In Response to Data Adequacy Review
of the
Application for Certification
for the
**GWF Energy LLC Tracy
Combined Cycle Power Plant
(GWF Tracy)**

(08-AFC-7)

Submitted to the
California Energy Commission

Submitted by
GWF Energy LLC

FIGURE TRANS-1
TRACY MUNICIPAL AIRPORT
INFLUENCE AREA
 GWF TRACY COMBINED CYCLE
 POWER PLANT PROJECT
 SAN JOAQUIN COUNTY, CA

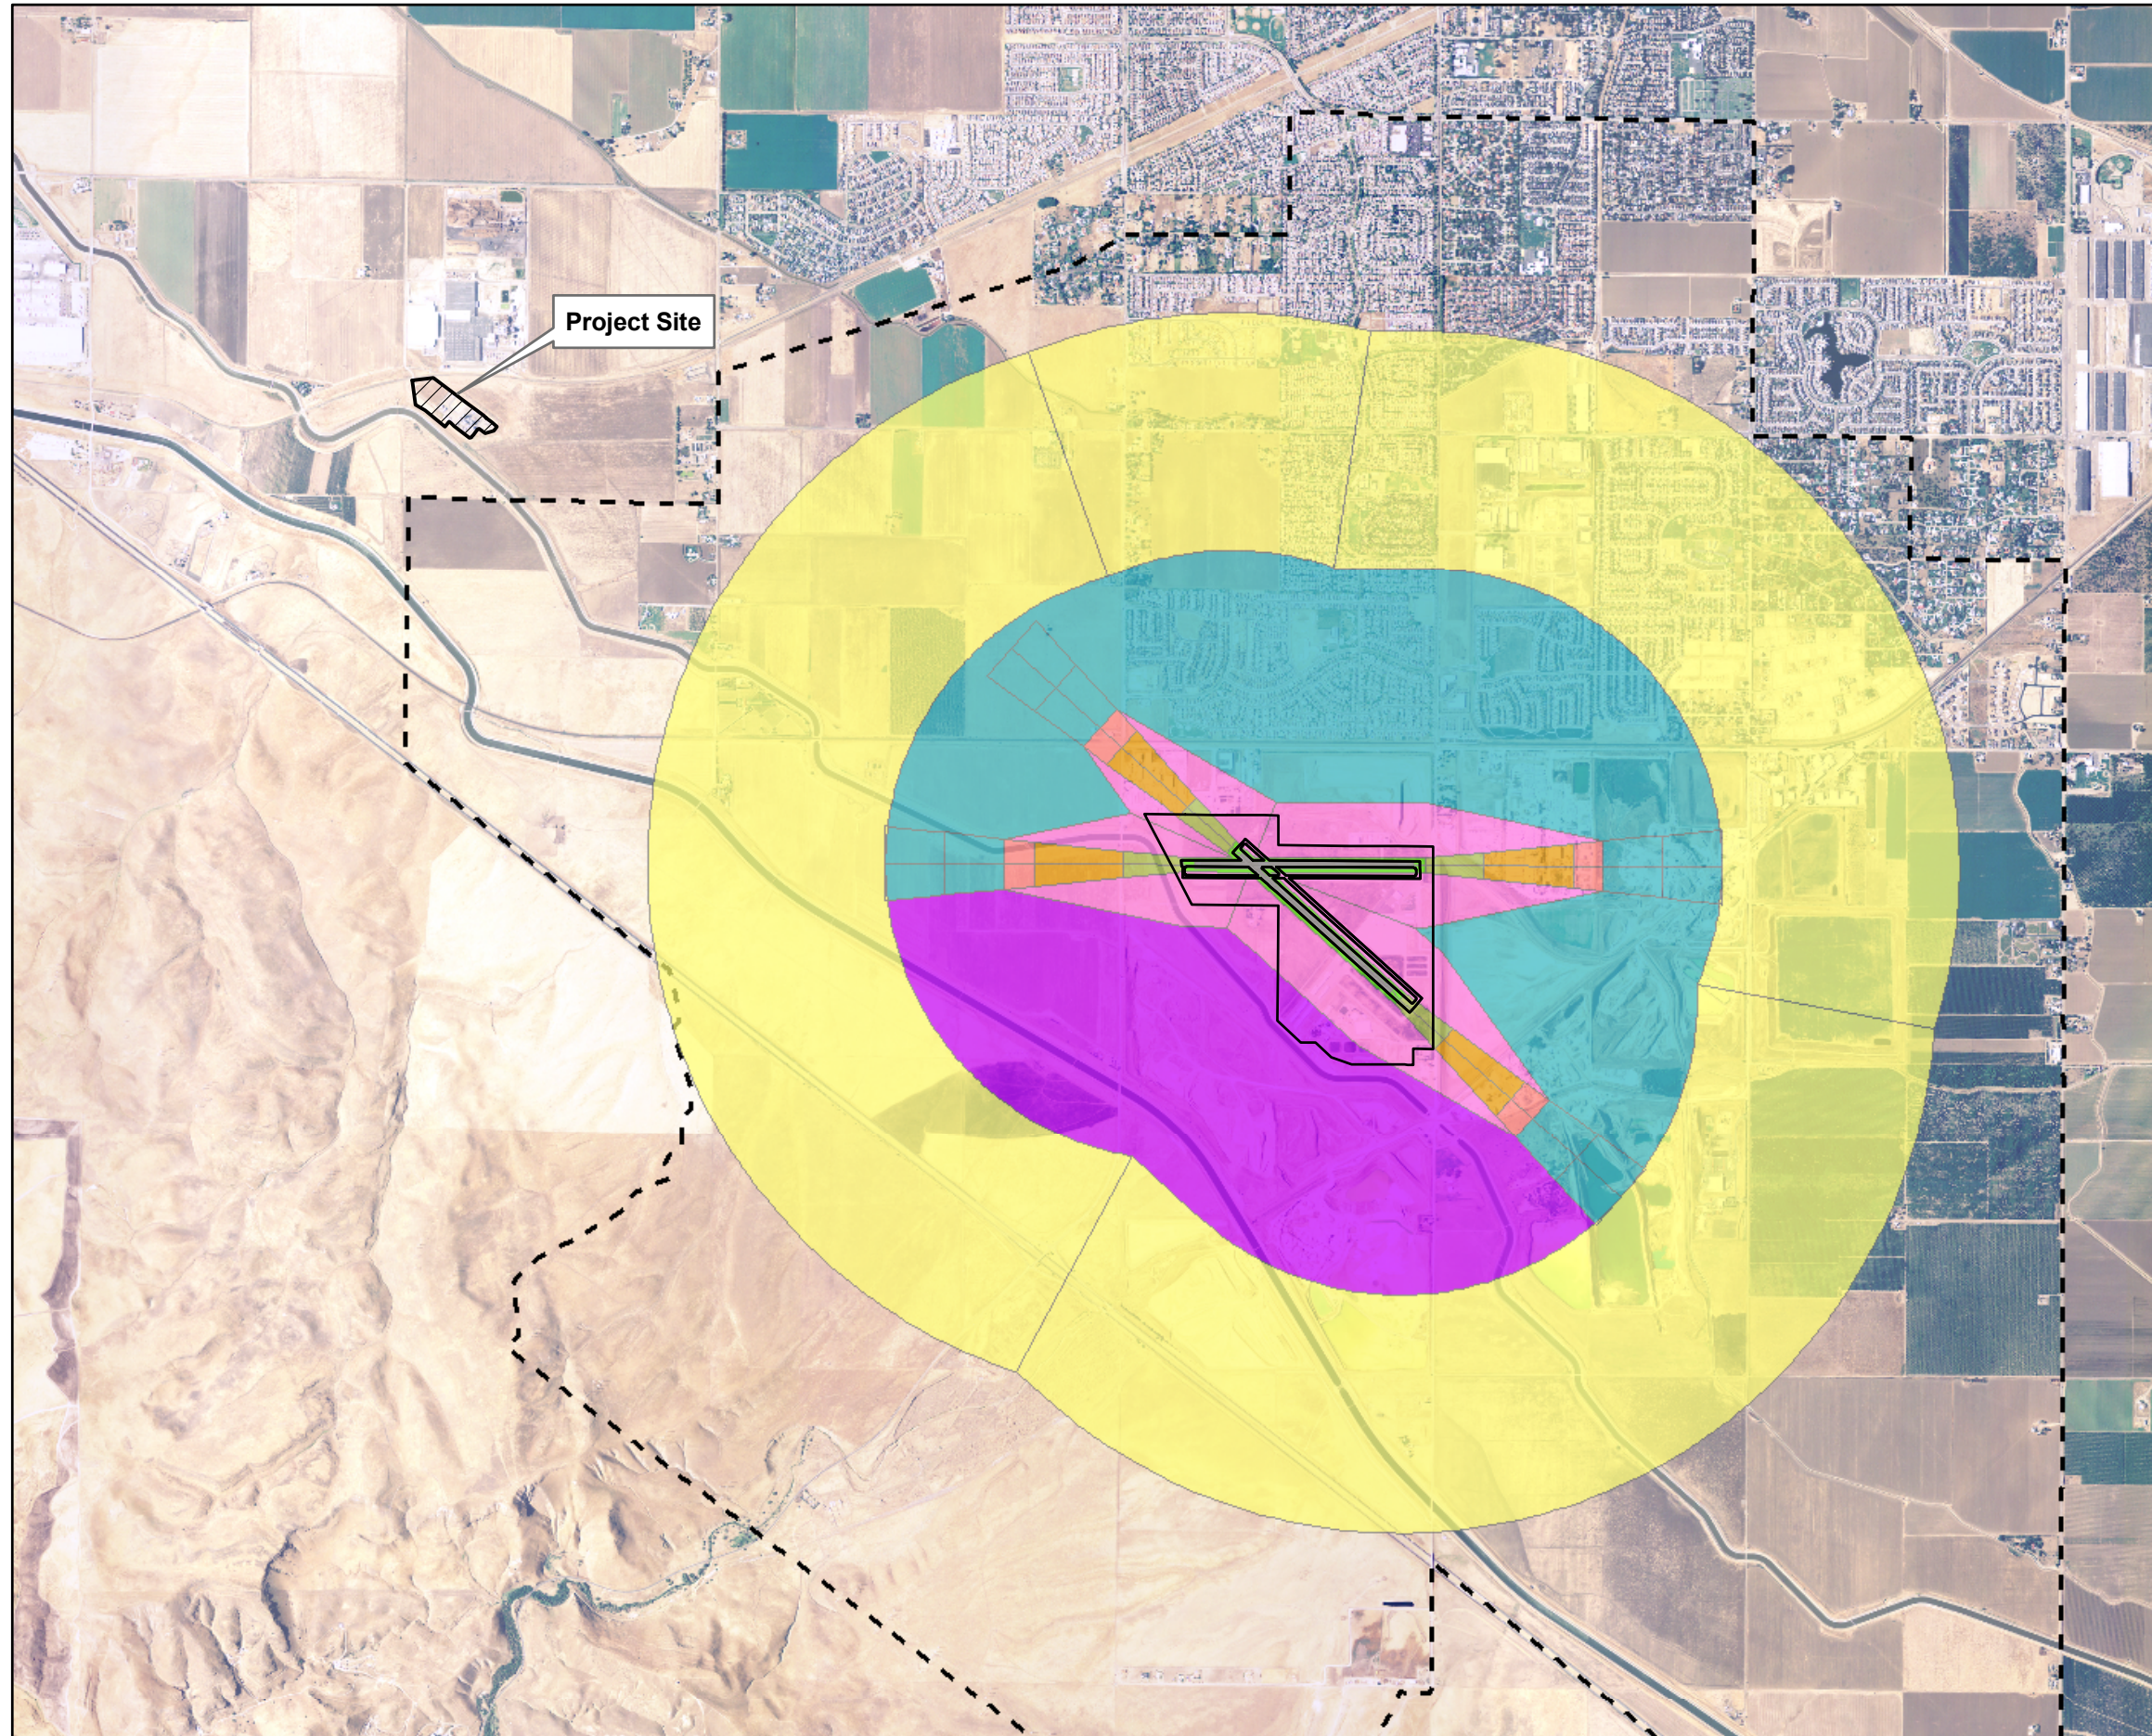
Please discuss the project's compliance with the applicable sections of the current Federal Aviation Regulation Part 77 – Objects Affecting Navigable Airspace, specifically any potential to obstruct or impede air navigation generated by the project at operation; such as, a thermal plume, a visible water vapor plume, glare, electrical interference, or surface structure height. The discussion should include a map at a scale of 1:24,000 that displays the airport or airstrip runway configuration, the proposed power plant site and related facilities.

Response – As discussed in AFC Section 3.3.2, the runway of the Tracy Municipal Airport is located about 14,000 feet away from the GWF Tracy project. Figure Trans-1 (which replaces AFC Figure 5.12-1) shows the location of the airport to the GWF Tracy project site. Below is a discussion of the potential project impacts to the Tracy Municipal Airport from plumes (thermal and visible), glare, and electrical interference.

As shown on Figure Trans-1, the plant is over 1000-feet northwest of the Airport Influence Zone. The plant will generate a thermal plume from the combustion turbine exhaust stacks, but the plume would not have an affect on aircraft since it is located well outside the Airport Influence Zone.
